#### **Addendum 50 – UN Regulation No. 51**

#### **Revision 3 - Amendment 3**

Supplement 3 to the 03 series of amendments – Date of entry into force: 16 October 2018

#### **Uniform provisions concerning the approval of motor vehicles having at least four wheels with regard to their sound emissions**

**Figure 2: Flowchart for the check on the necessity for a silencer conditioning test**

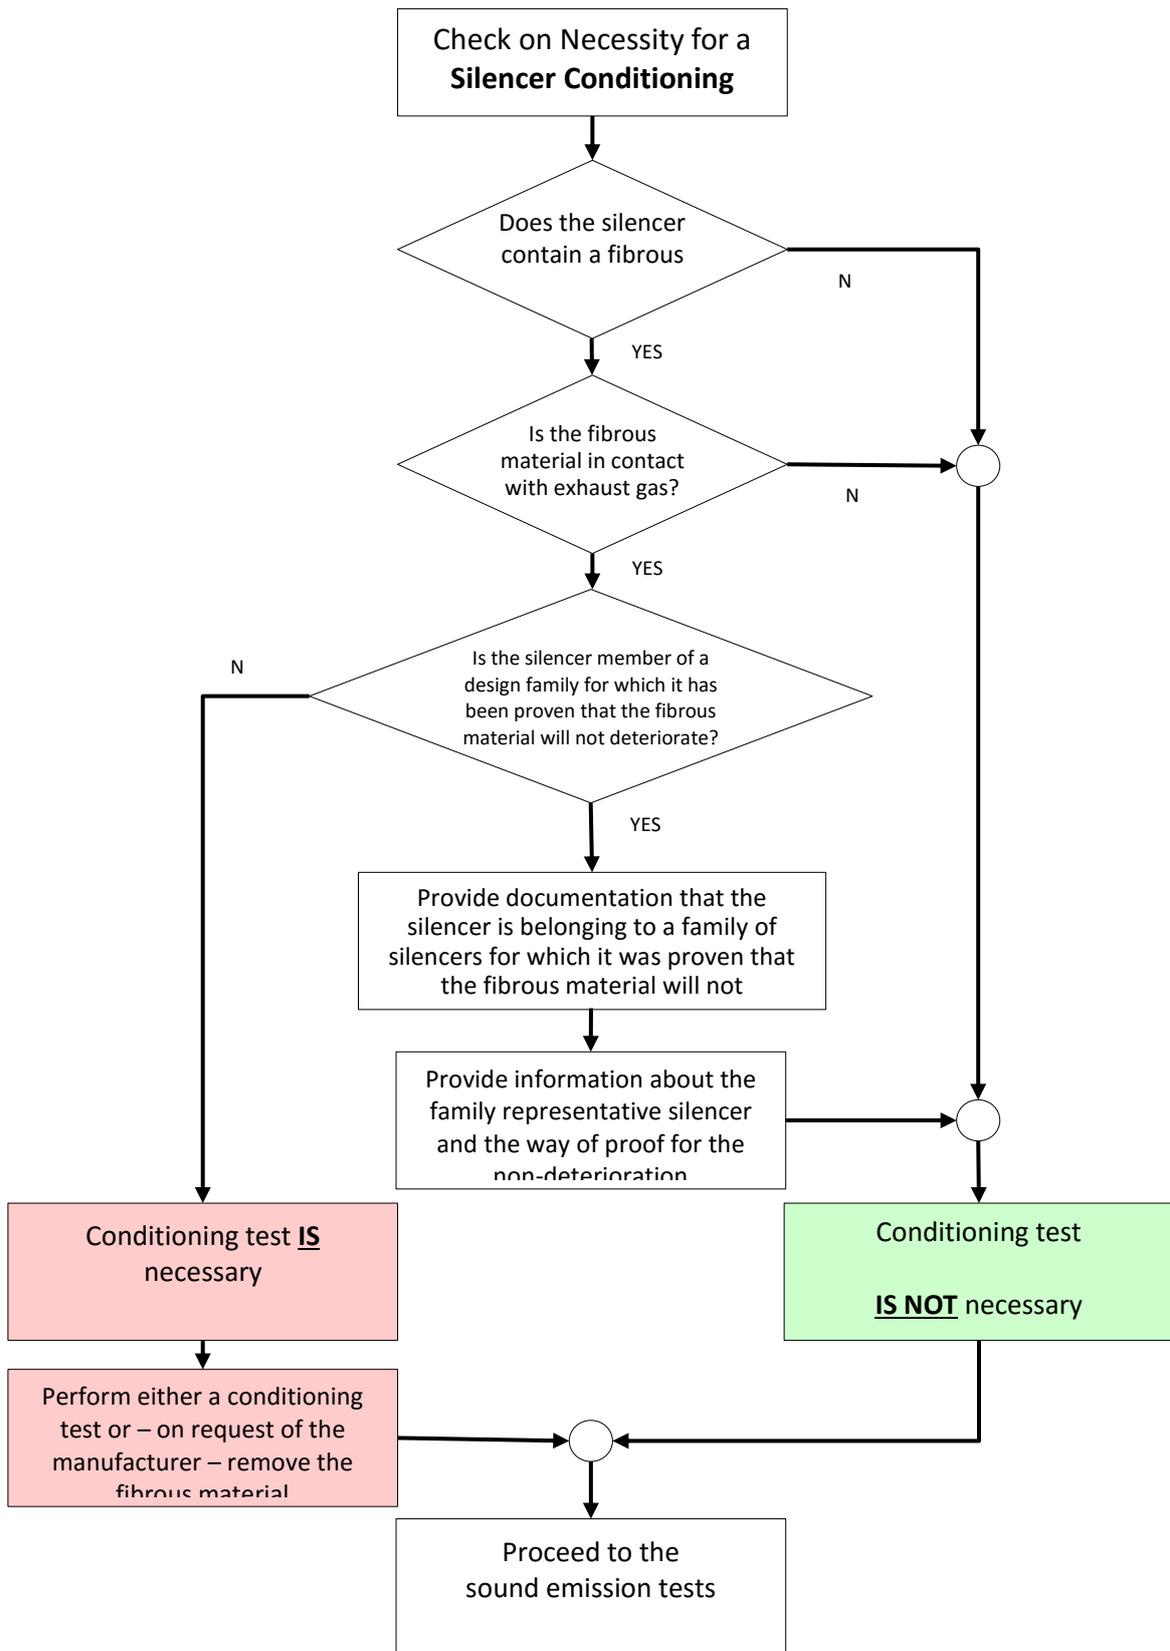
*Appendix, add a new flowchart to read:*
